# GNF/GEH Perspective on DG-1261, 1262, and 1263

Public Meeting on Draft Regulatory Guides

April 29-30, 2015, ORNL

Figure 4. Histogram of AOR Oxidation Results

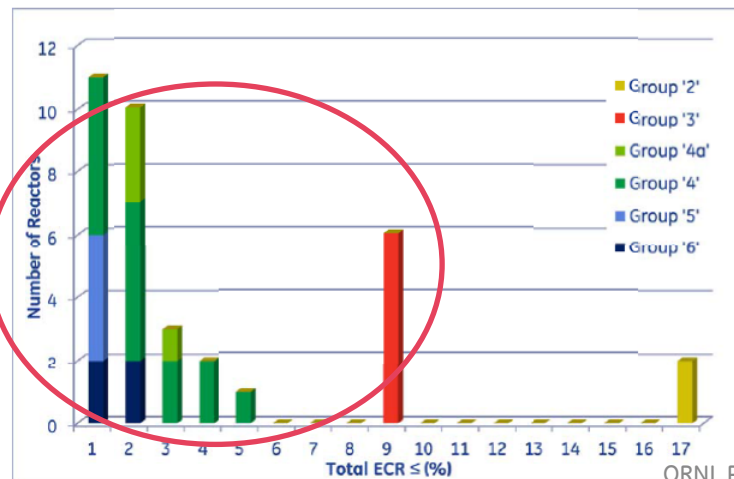
- Scratches (small impact)
- Surface contaminant (strong impact)
- Source material type from Zr extraction (strong impact)

## Low risk of current Zry2 used for BWR

Majority have <1000s  
above 800°C
